Report to Planning and Environment Committee

To: Chair and Members
Planning & Environment Committee
From: Scott Mathers, MPA, P.Eng.,
Deputy City Manager, Planning and Economic Development
Subject: Draft Plan of Vacant Land Condominium on the Submission
by Bluestone Properties Inc. for 7098-7118 Kilbourne Road
Public Participation Meeting on: October 5, 2022

Figure 4: Open Space Lands Conveyed To The City

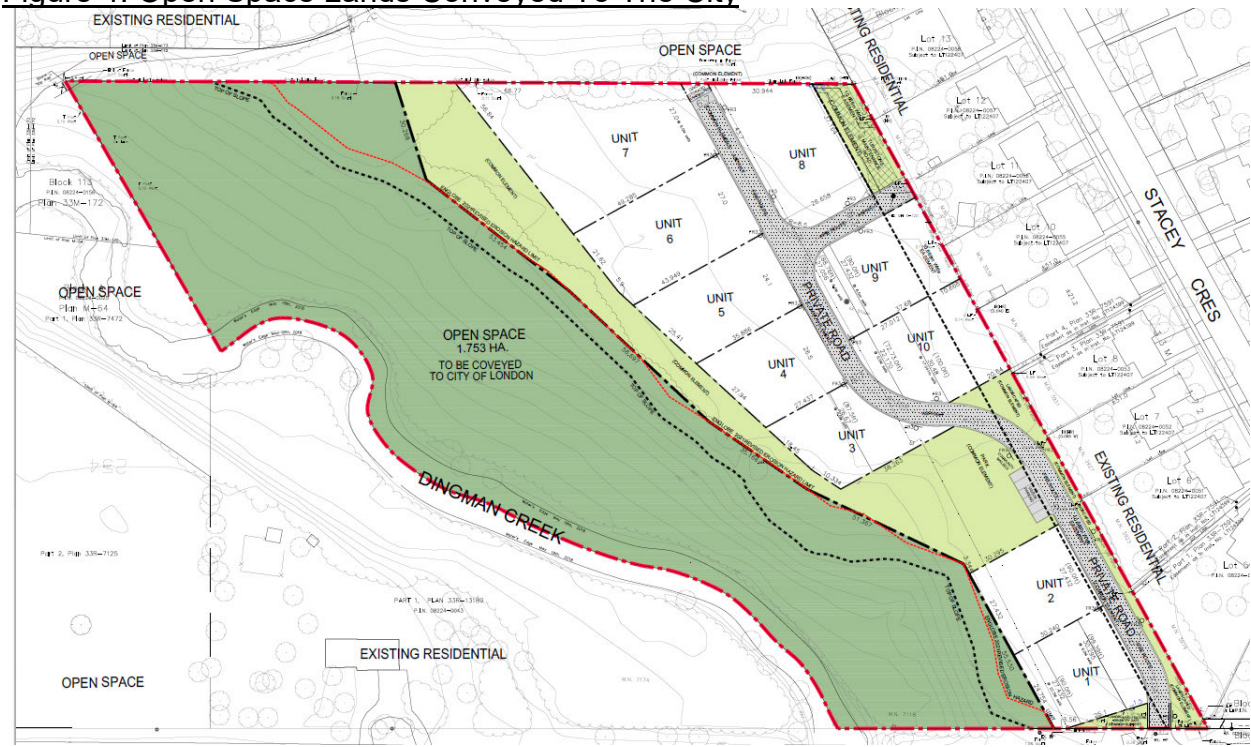
Within the open space to be conveyed to the City, portions of land have been identified to accommodate a multi-use pathway (See image below). Additional setbacks also exist along the northern property line where additional open space lands exist. As a result of the proposed open space lands staff are recommending that these lands be designated as a Green Space Place Type in The London Plan. and zoned Open Space (OS5) Zone in the Zoning By-law.

Lands west of the Development Limit (common element) shall be dedicated to the City
